Livestock Plaza/Sheep Barn

Addendum Issue Date: 8/8/24

The following changes, revisions, or clarifications shall be made to the drawing documents.:

SHEET: A5.3

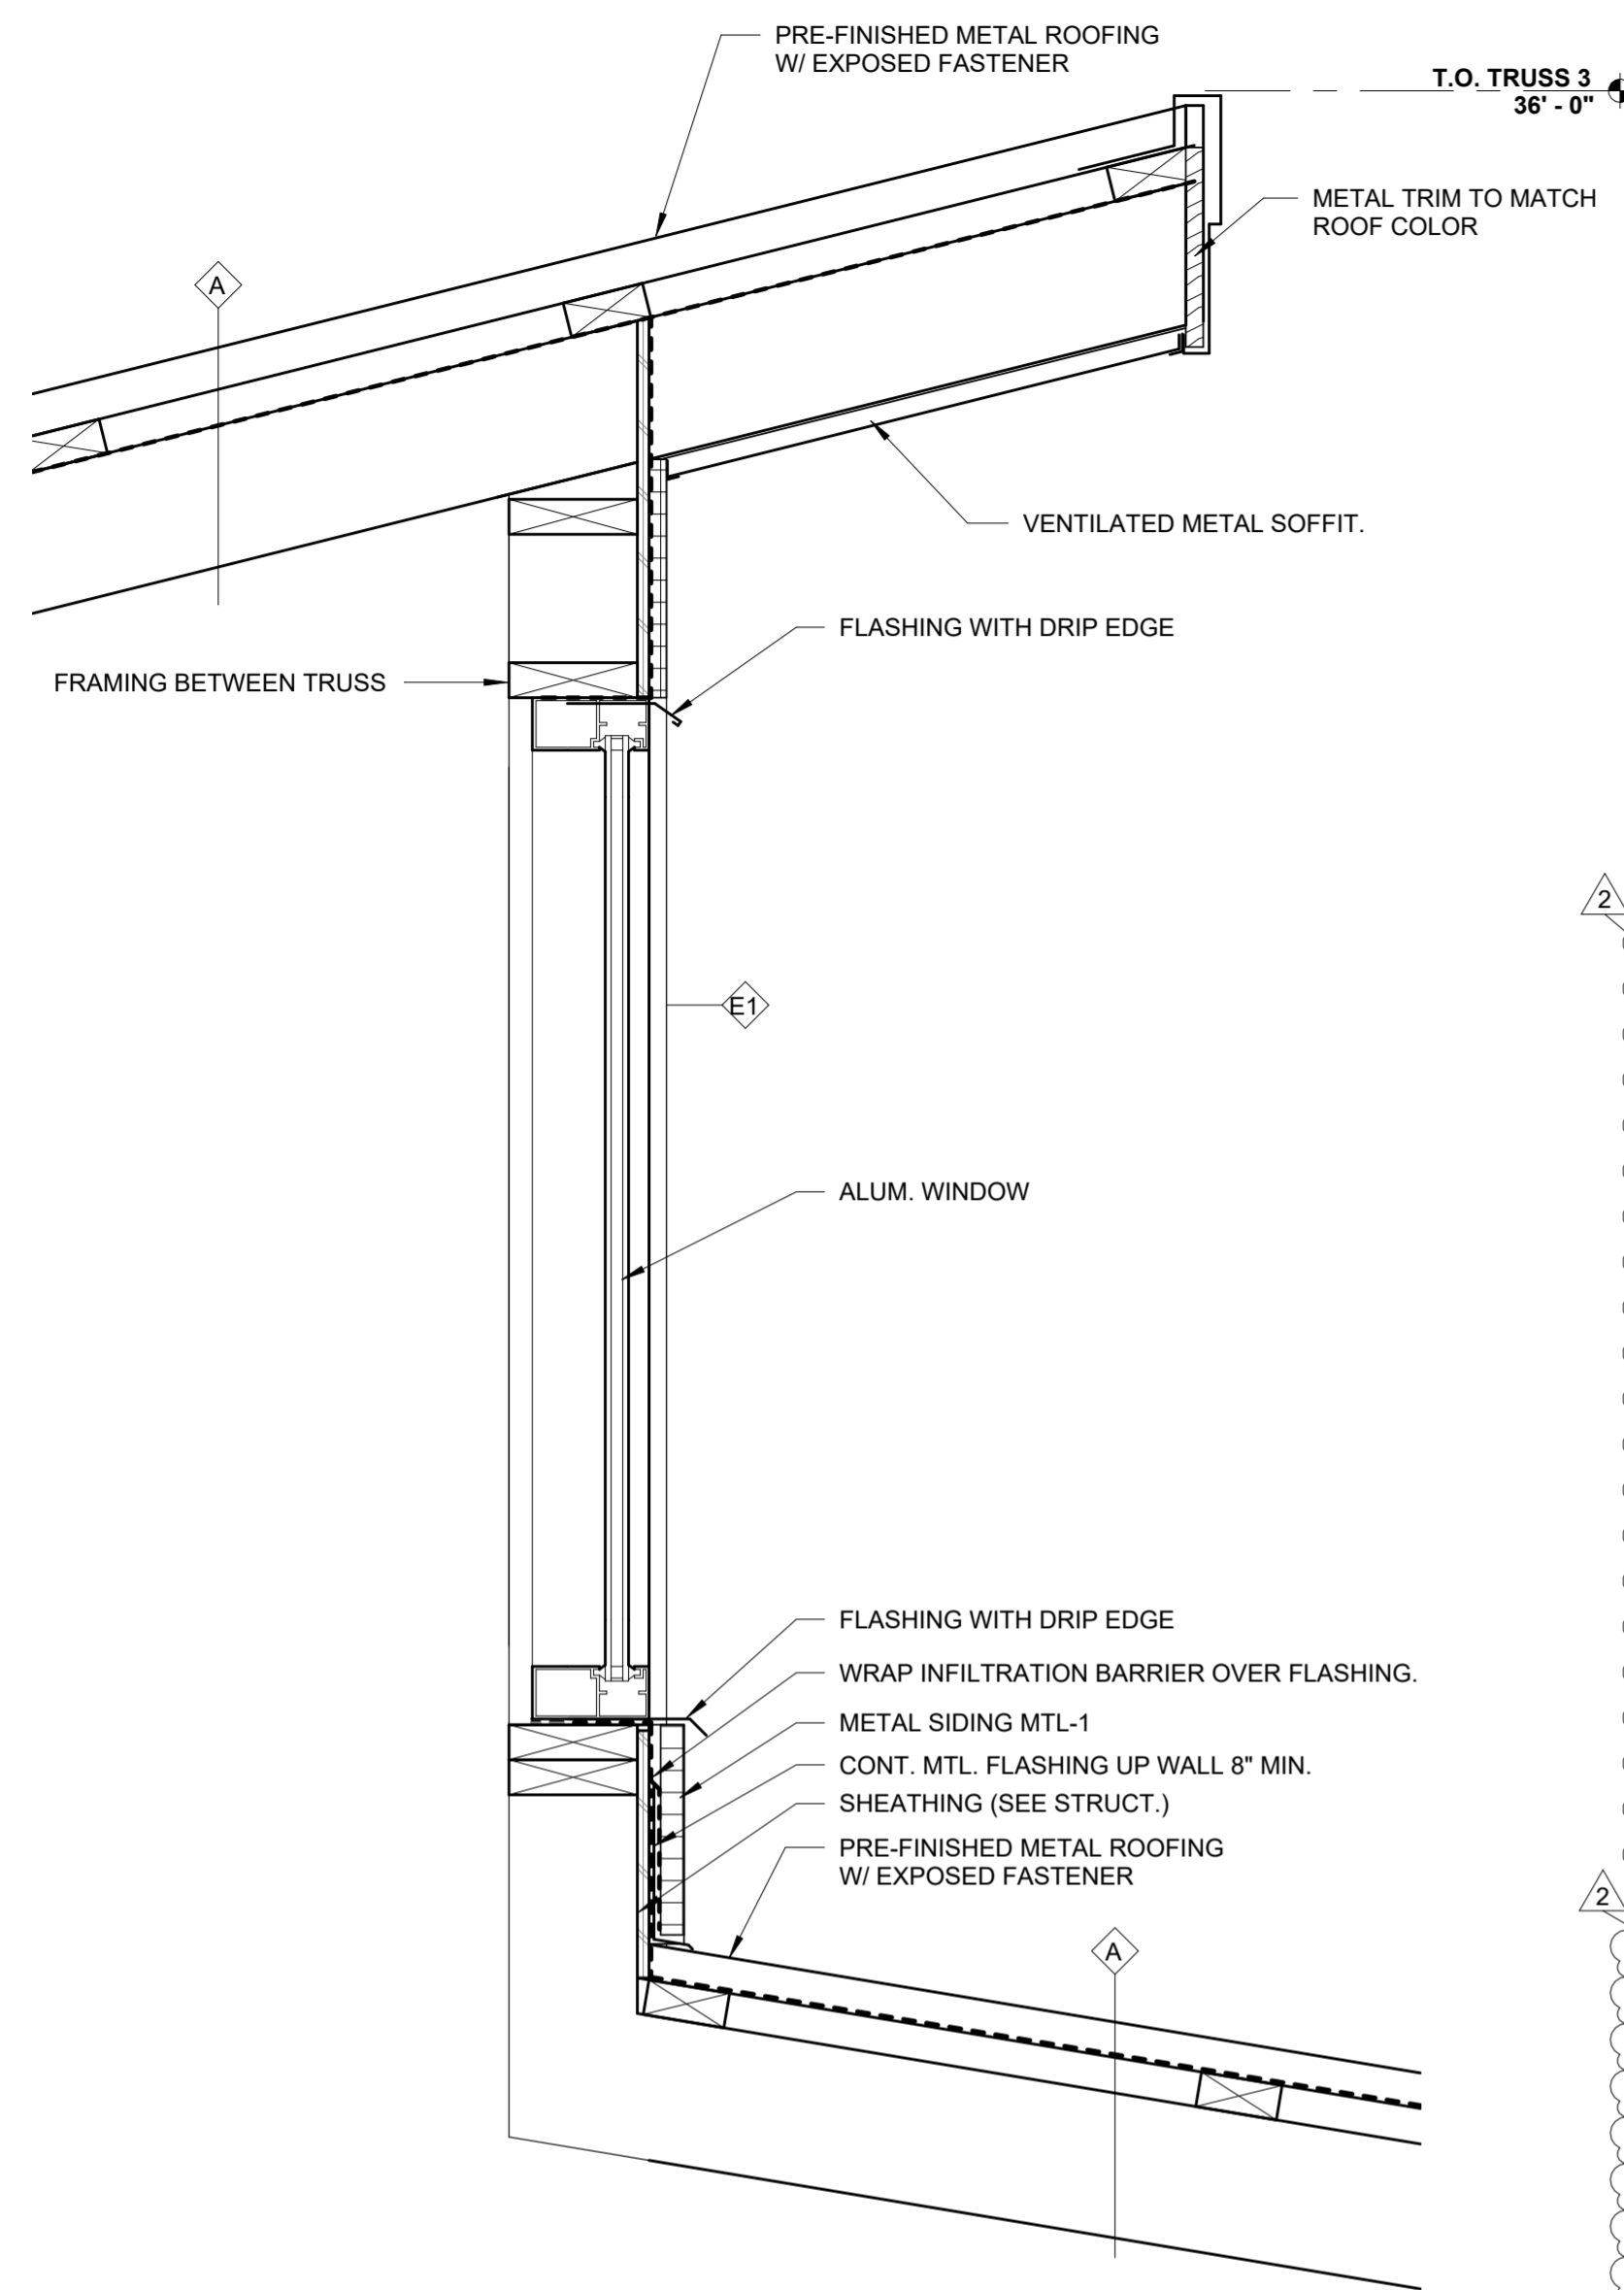
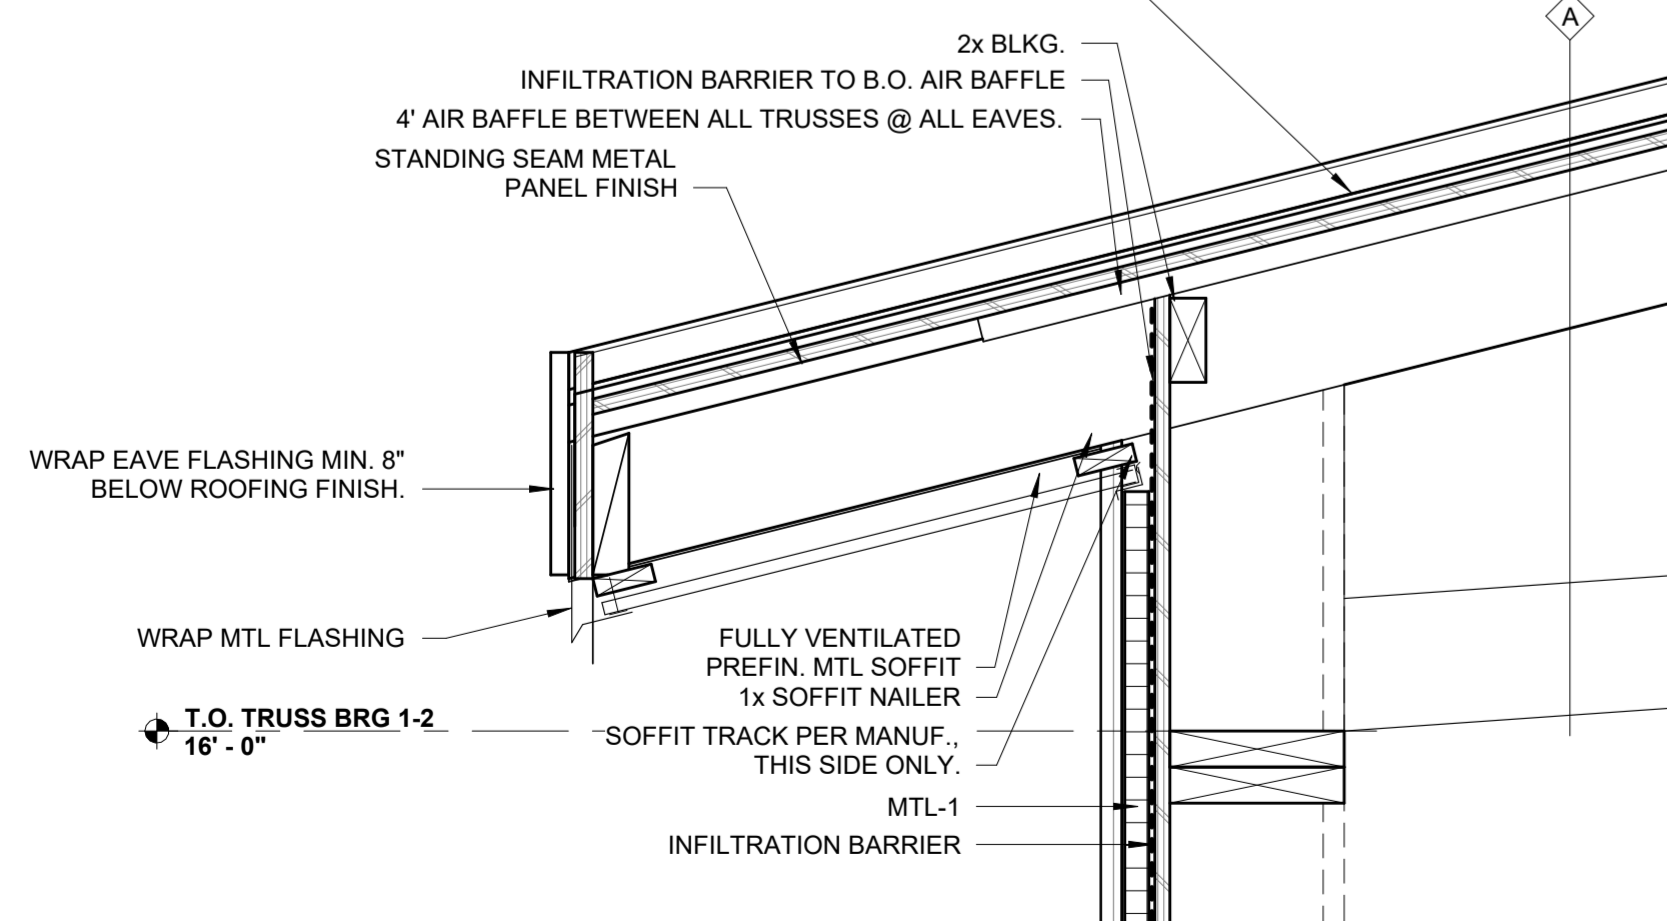
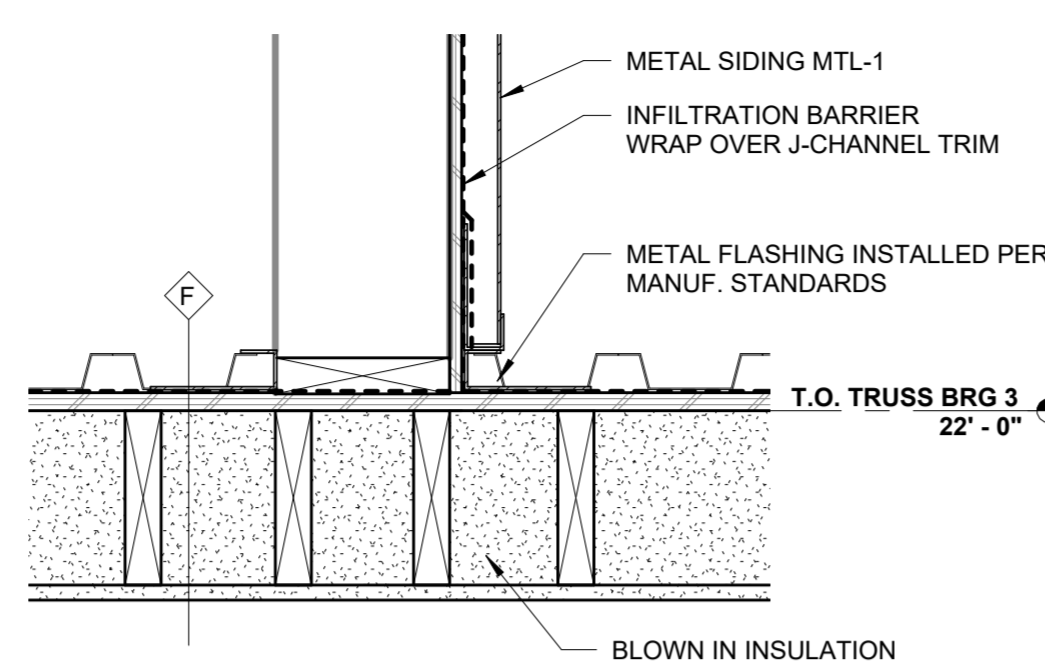
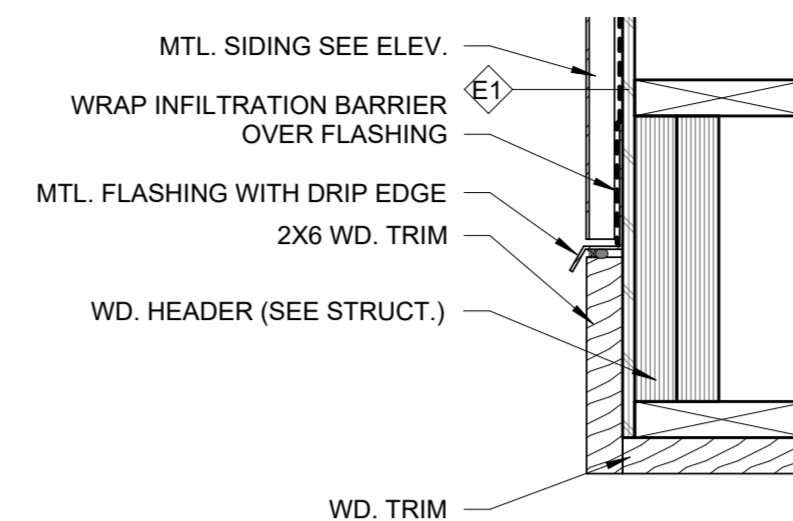
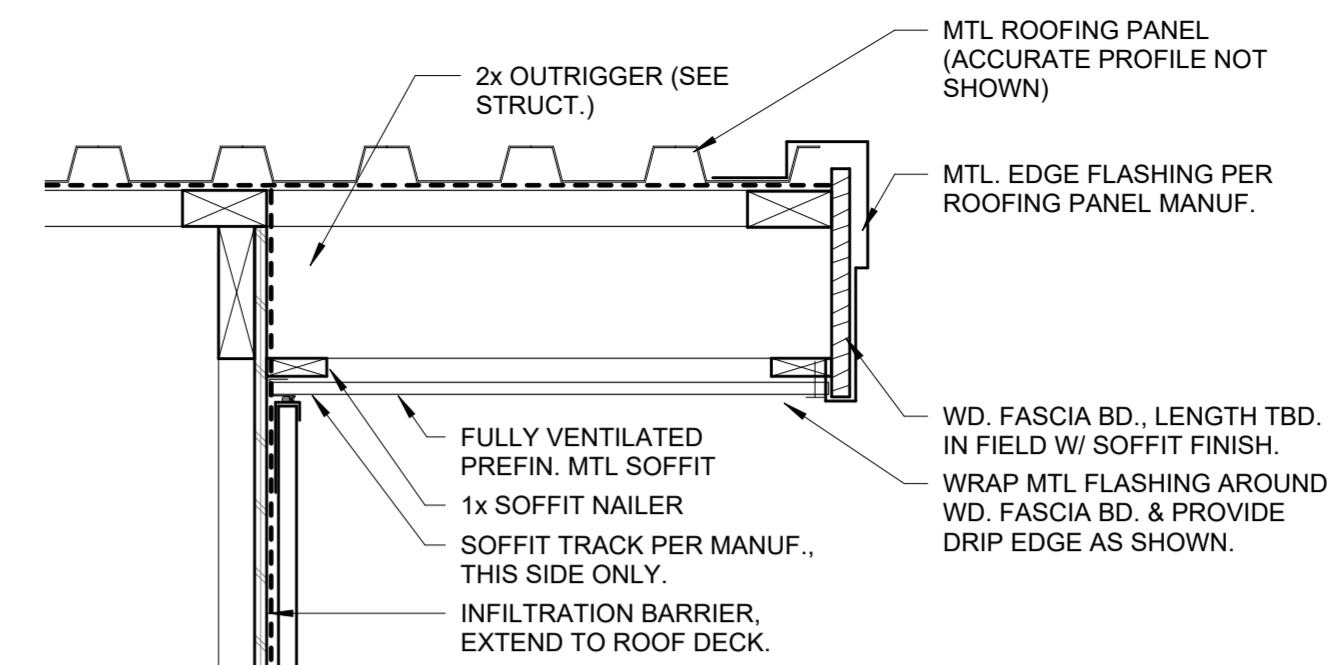
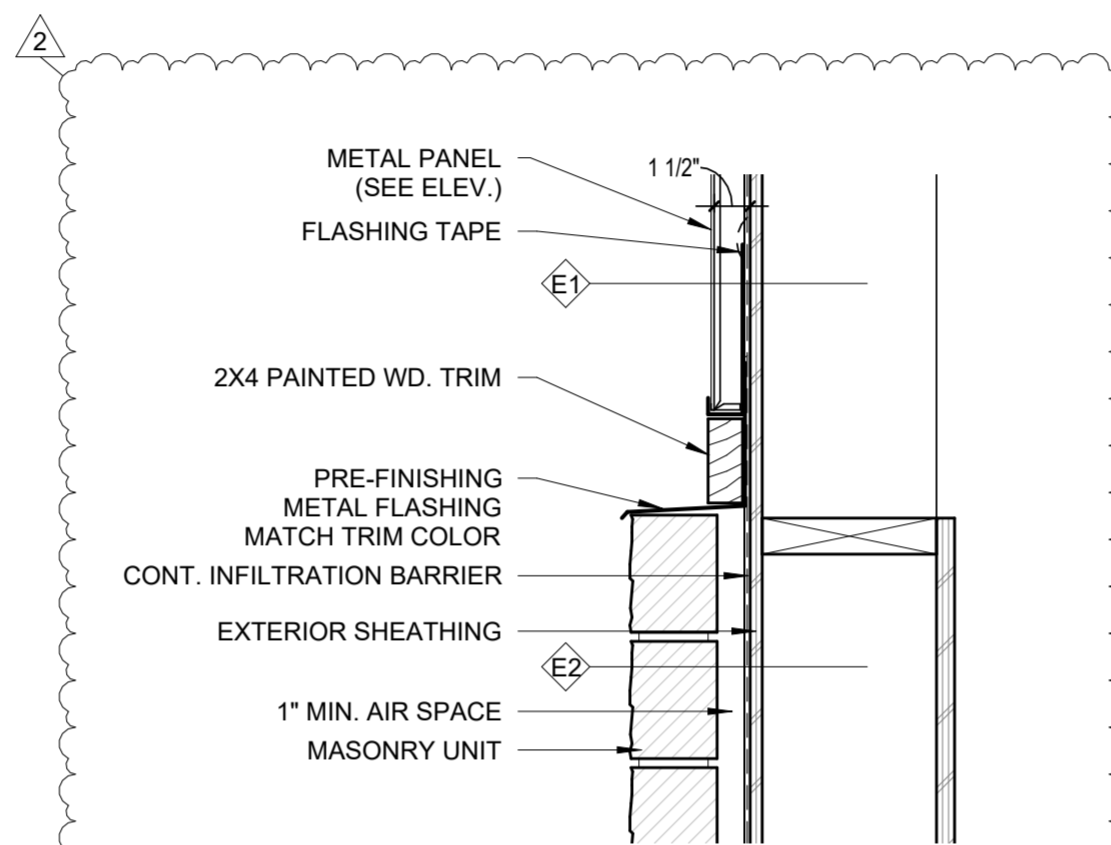
Sheet A5.3 - Details:

Details have been revised.
